London 2012 Olympic Park

Follow-on Project (Stage 2) Consolidated Validation Report – Planning Delivery Zone 1

December 2012

- Appendix A: Glossary of Terms and Definitions
- Appendix B: Schedule of Key Documentation (including summary of contents)
- Appendix C: Key Parties
- Appendix D: Permit to Proceed Protocol (CD only)
- Appendix E: Supporting Information
- Appendix F: PPDT / Hyder Document Review Comments and Responses

Figure 11 Representative As-Built Sections of the Final Remedial Cover System in Planning Delivery Zone 1

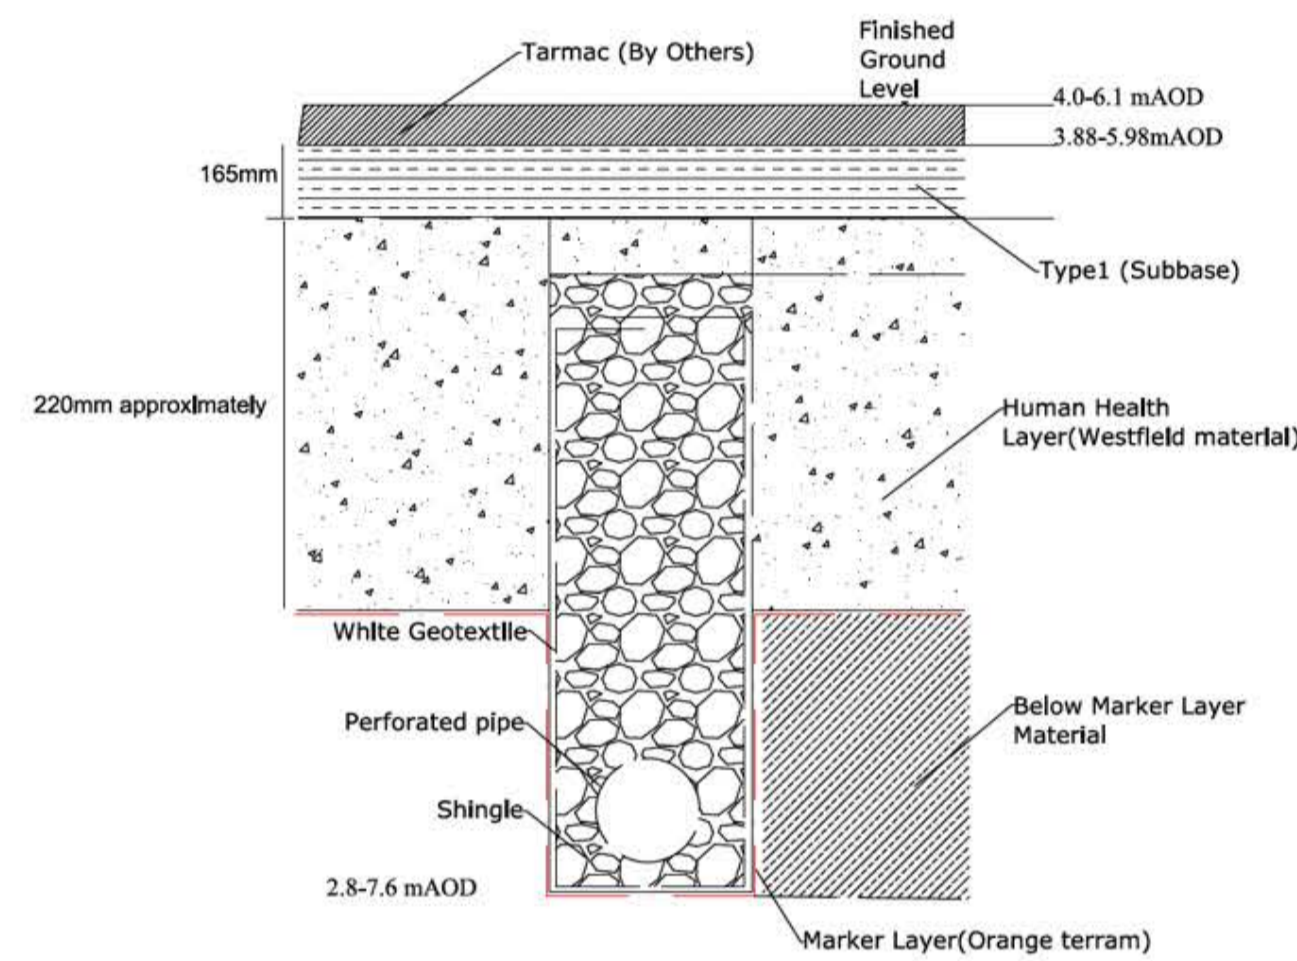
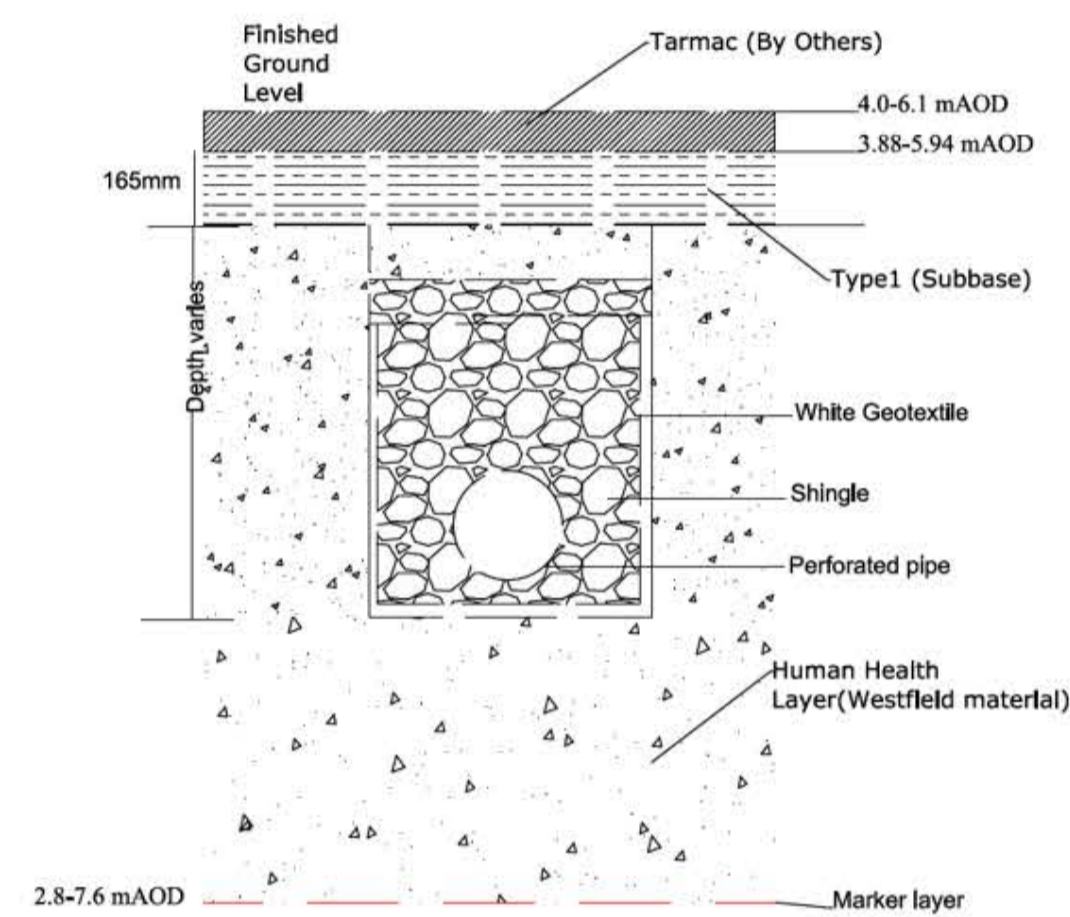
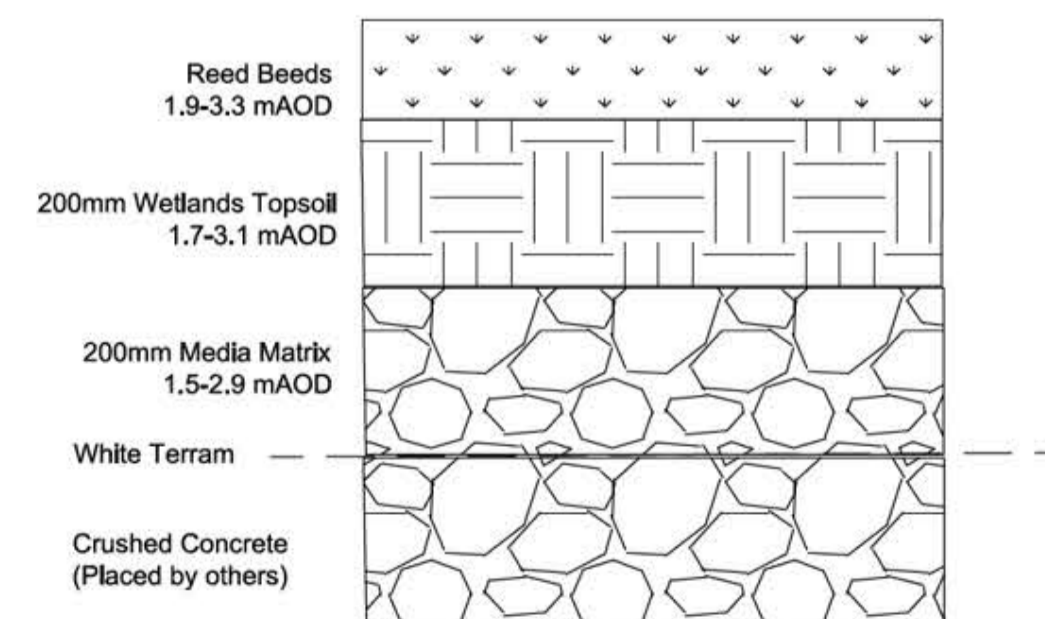
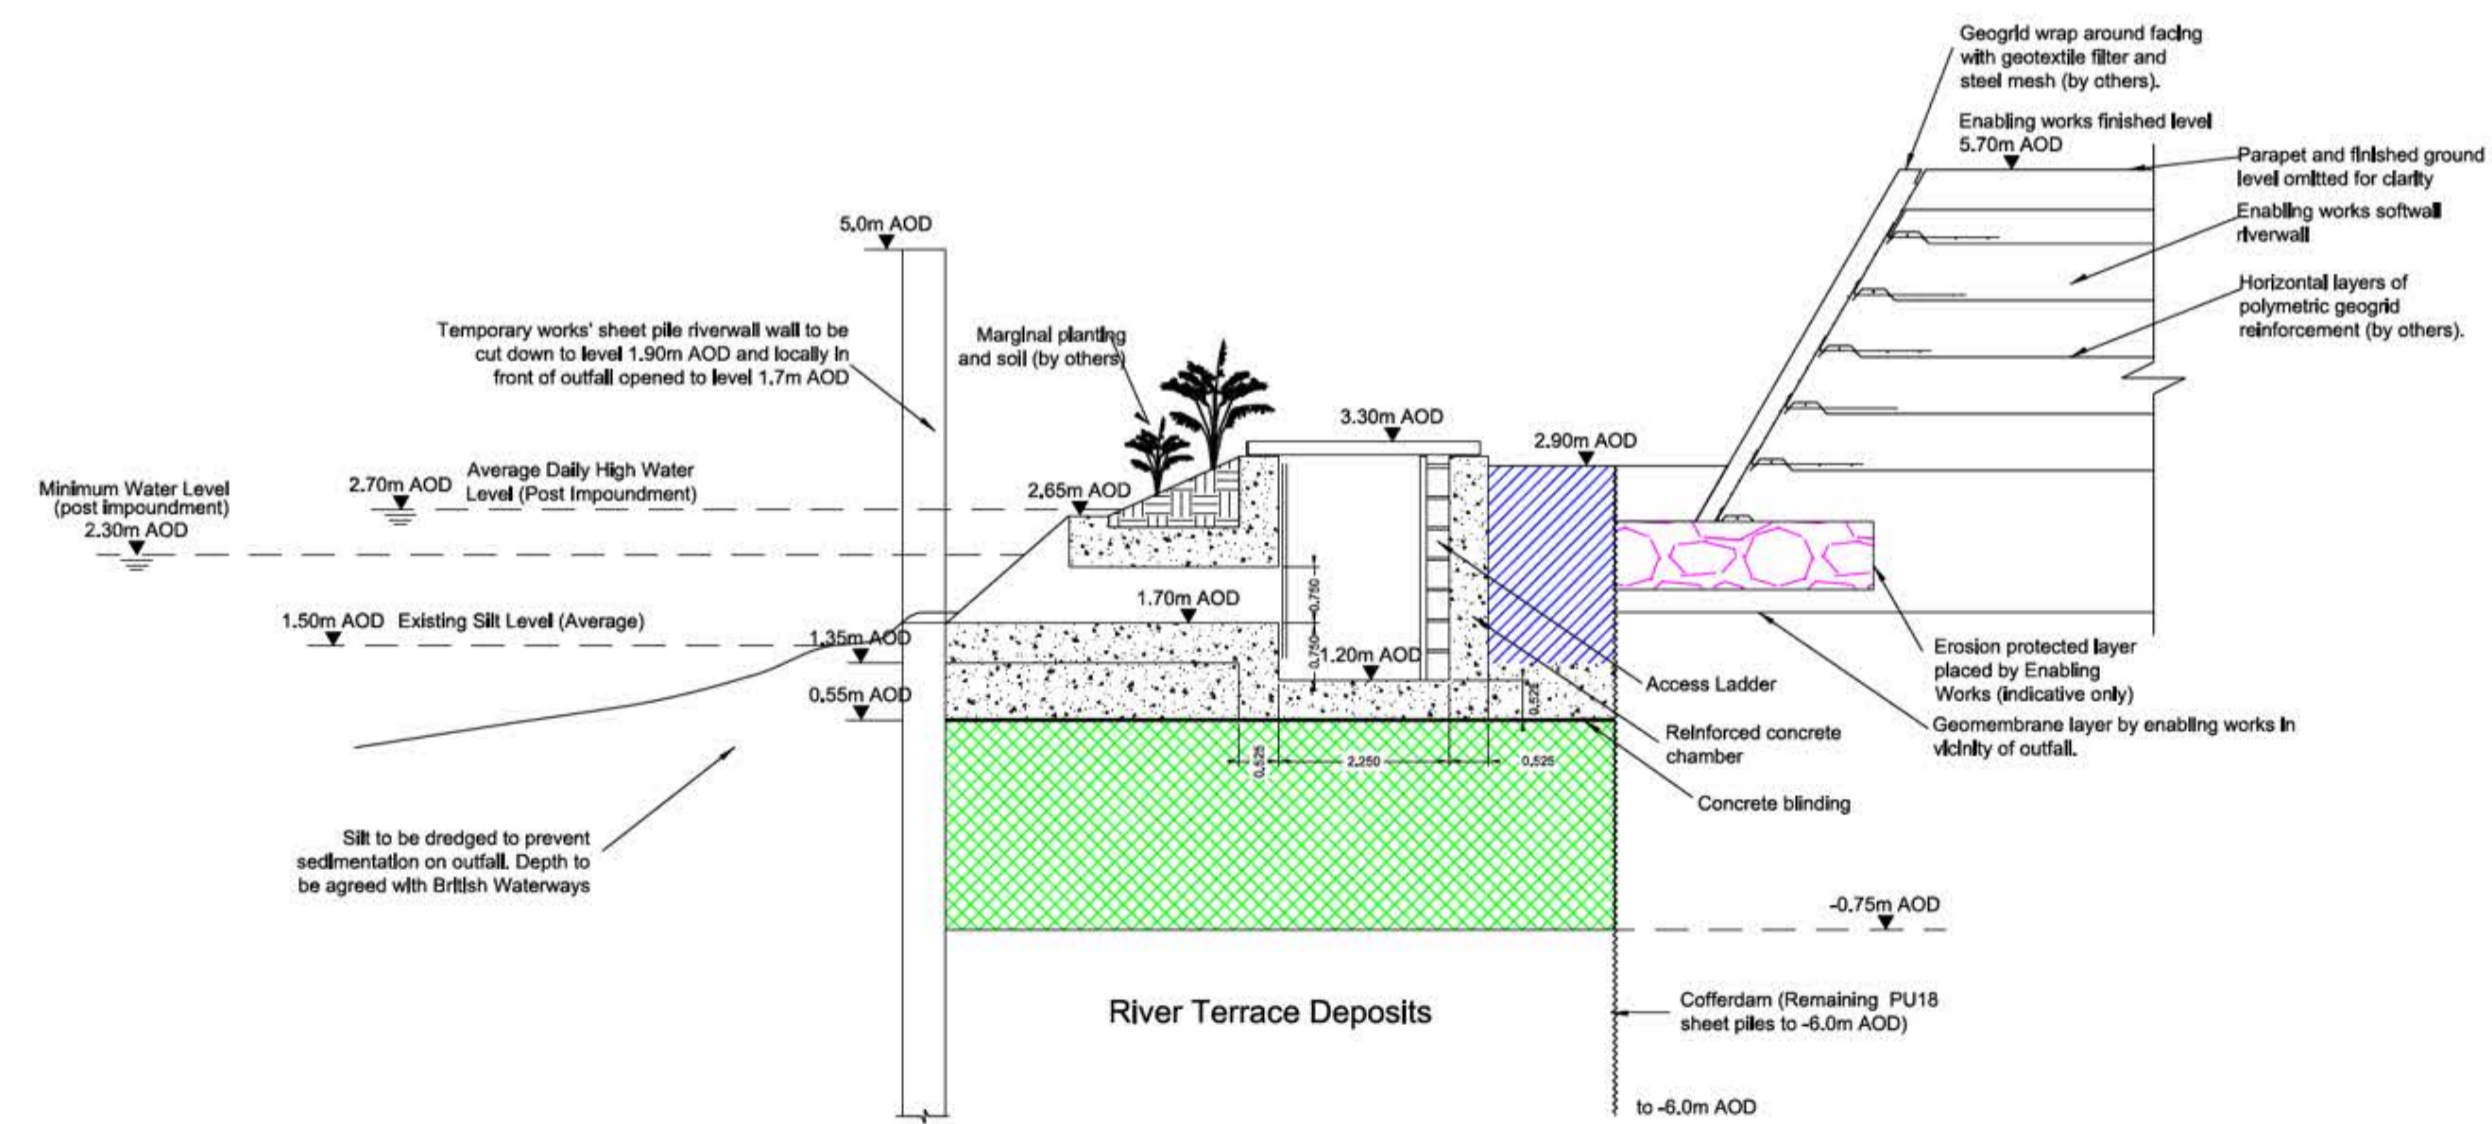
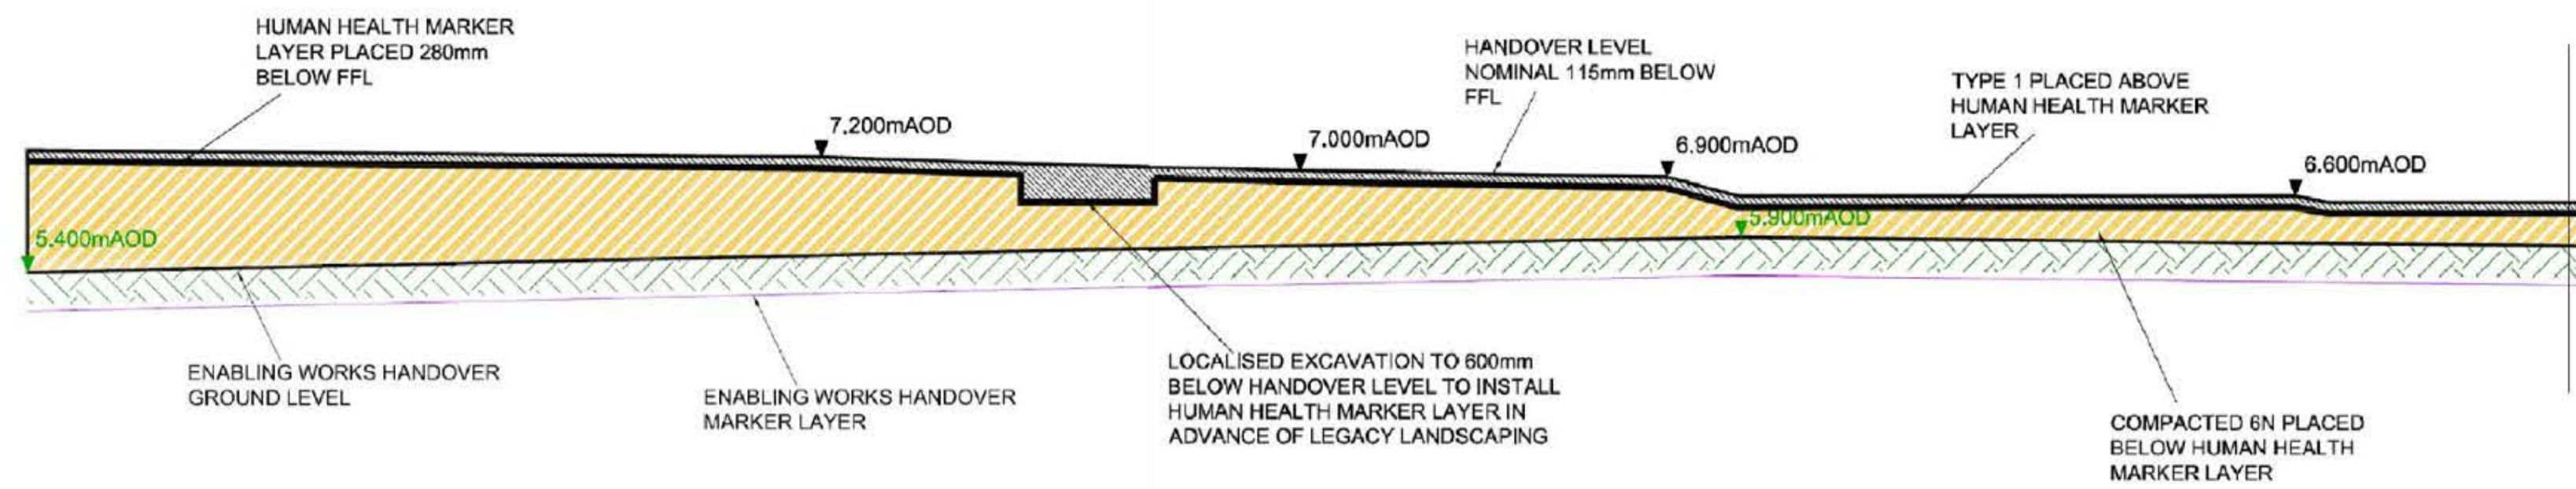
1.11	Appendices –Figures List	Please ensure the title for Figure 11 is consistent with the title given on the Figure 11 drawing.	Response 03/12/12: The drawing title and figures list will be checked for consistency. Hyder 06/12/12: Assuming this is done adequately prior to PPDT submission, no further comment. RemTech response 07/12/12: This has been checked for the final attached submission. Hyder 07/12/12: No further comment.

1.31	Figure 11 Typical Sections of the Final Remedial Cover System in PDZ1	<ul style="list-style-type: none"> It is difficult to read much of the text relating to the scanned sections provided on this drawing. Please could the scan quality be improved to aid the reader. Typical sections should be presented for all key surfacing types for the PDZ in question i.e. soft and hard landscaping, utilities, roads etc and clear indications where building footprints are present. Please could the applicant confirm / ensure that all representative key types are included in this drawing. Please could the applicant confirm the sections show as constructed details and update the drawing notes to state such. 	Response 03/12/12: Drawing amendments / response to comments are to follow. Hyder 06/12/12: Revised Figure 11 not received. In abeyance. RemTech response 07/12/12: Please find the drawing attached. We have tried to identify available sections which are representative of the exterior areas in PDZ1 and for where we have good quality as-builts. The text in Section 3.1 of the report has been amended to highlight which project sections are shown on the new Fig 11. Hyder 07/12/12: No further comment.
